Docket Item # 12
BAR CASE # 2016-0178

ISSUE: Waterfront Common Elements

APPLICANT: City of Alexandria, Department of Project Implementation

STAFF RECOMMENDATION

PAVING - PROMENADE DECKING

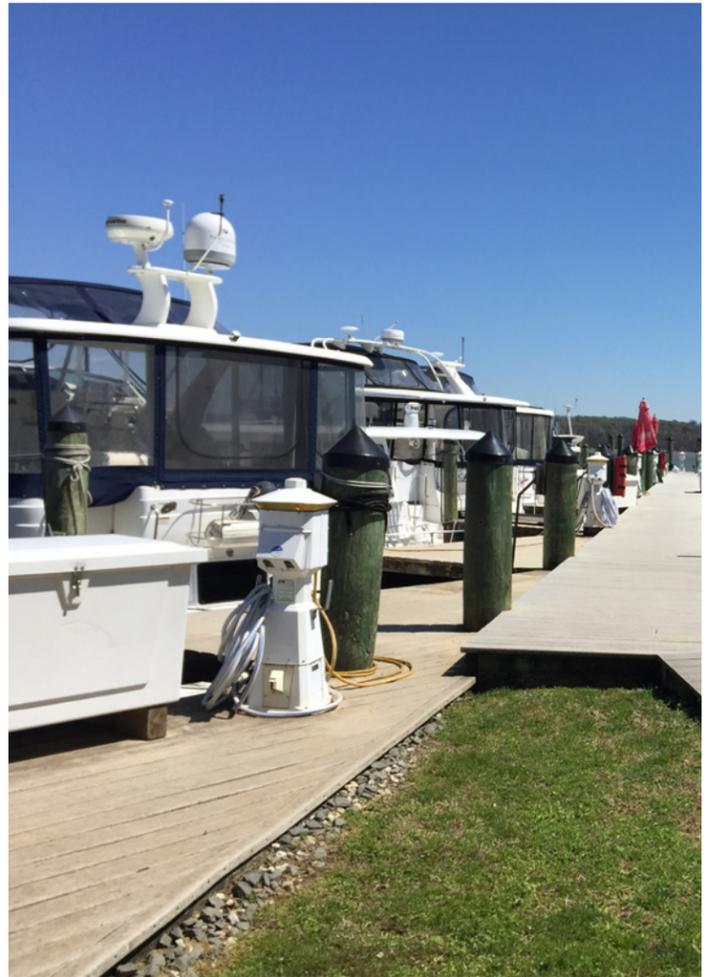
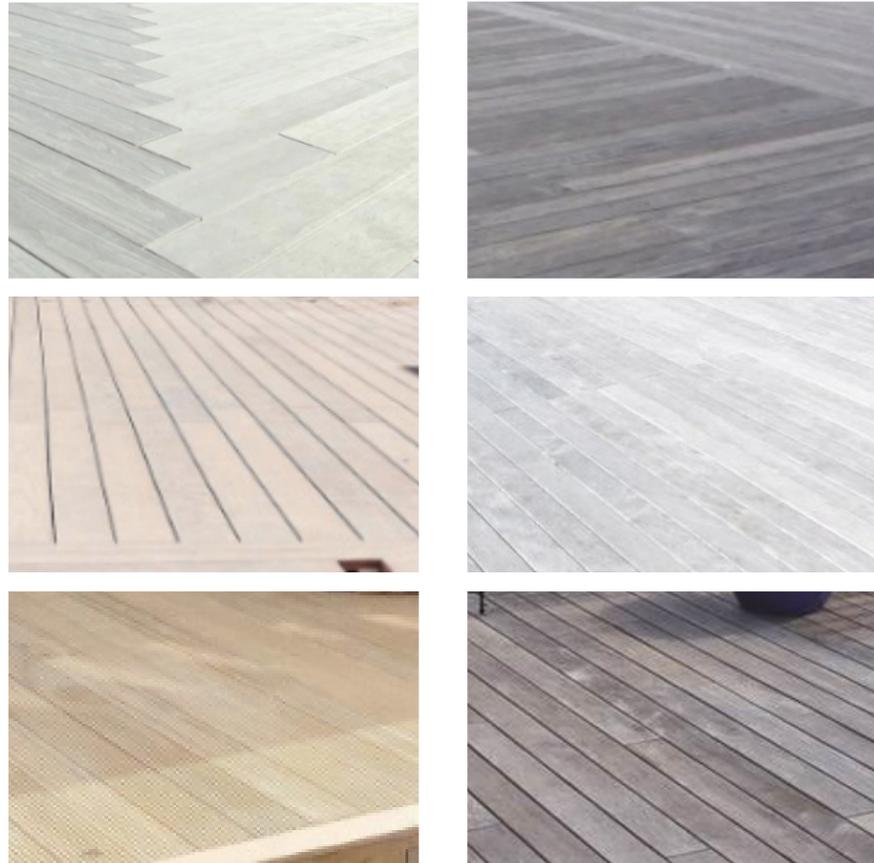
1. To the greatest extent possible, the lower boardwalk along the promenade should be constructed of durable wood (natural or modified) rather than a composite material.
2. The associated year (1749 or 1845) should be engraved at regular intervals for the shoreline and pier line demarcations.

Staff supports the use of concrete plank pavers and the tonal color family proposed to minimize glare and for long term maintenance reasons. Staff supports the wider granite banding on each side of the promenade to enable more robust inscriptions in some designated areas but recognizes that design constraints may require the narrower banding where the promenade is narrower outside of the core area. In certain locations, adjacent to the river, the promenade will feature a lower boardwalk adjacent built of a decking material (pressure-treated pine, Trex composite, or modified wood). The BAR approved a change from treated lumber to composite planks at the City Marina approximately 15 years ago because of ongoing maintenance reasons, and this is consistent with the BAR's current Modern and Sustainable Materials policies. Staff recommends that durable wood decking be used as the primary decking material and that composite decking (Trex is a common brand that is made from recycled sawdust and plastic bags) should be used minimally, as necessary.

1749 HISTORIC SHORELINE

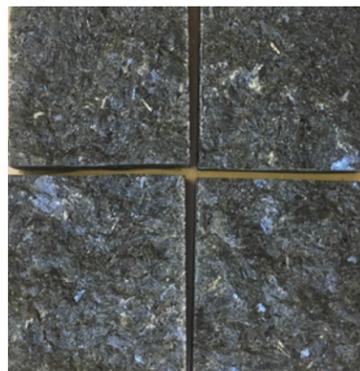
Staff supports the proposed demarcation of the 1749 shoreline and 1845 pier line with the stone bandings noting that this form of historic interpretation will spatially explain the evolution of the waterfront as the land was pushed out over the marsh to the channel of the Potomac. The 1749

shoreline will be marked with 4” square granite cobbles in a dark/black color with a tumbled finish. The 1845 historic pier line will be 6” wide granite pavers in a medium gray granite with a thermal finish. In order to make sense of the shoreline and pier line, staff recommends that at regular intervals the associated date be marked in the stone. However it is recommended that as the park design and waterfront “rooms” evolve, that the banding be carefully integrated into the design so as to appropriately convey these elements. For example, there must be additional consideration to how the pier line is depicted through the lawn area for public safety and maintenance.

NAUTICAL

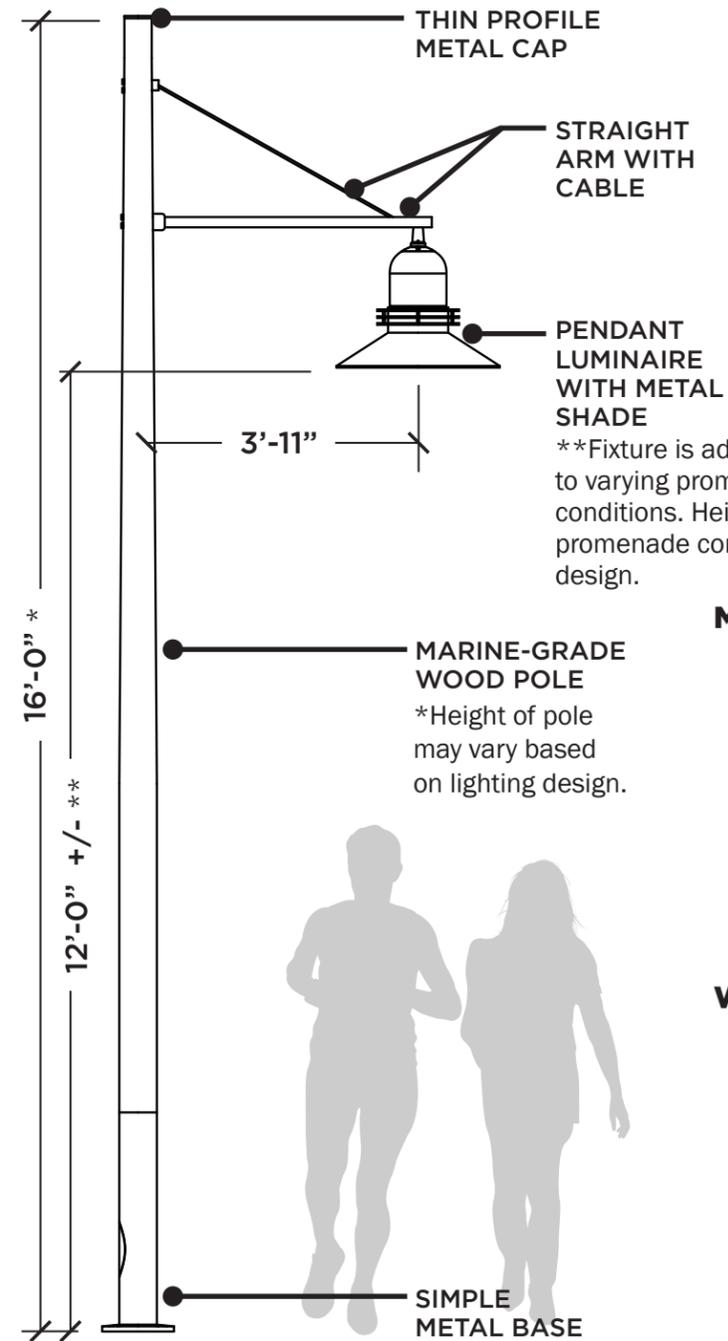
Based on positive feedback from the Waterfront Commission and Alex Engage, the current proposal is a refinement of the Nautical light, a treated wood pole with simple lines and a cable and straight metal arm with a metal pendant luminaire directing light downward. The pendant style is nautical/maritime in character, and the wooden pole recalls the masts and rigging of the multitude of wooden ships that once docked here, yet is simple enough to be harmonious with a wide range of historic and contemporary architectural styles and building typologies in both the historic district and Old Town North. The natural wood light pole will be 16 feet in total height with the light fixture at 12 feet. Black trim on the light will recall the other City standard furniture and infrastructure. Where the promenade has a lower boardwalk, the light will have two pendants but in other locations it will have a single pendant. The light fixture will be unique to this area but its simple lines and proportions will allow the lights to not detract from the view of the Potomac River. The light fixture head is designed to direct illumination downward to maintain dark skies and provide efficient illumination without glare when viewing the river from the parks, or when viewing the historic buildings from the river at night. Staff supports the proposed Nautical design promenade light.
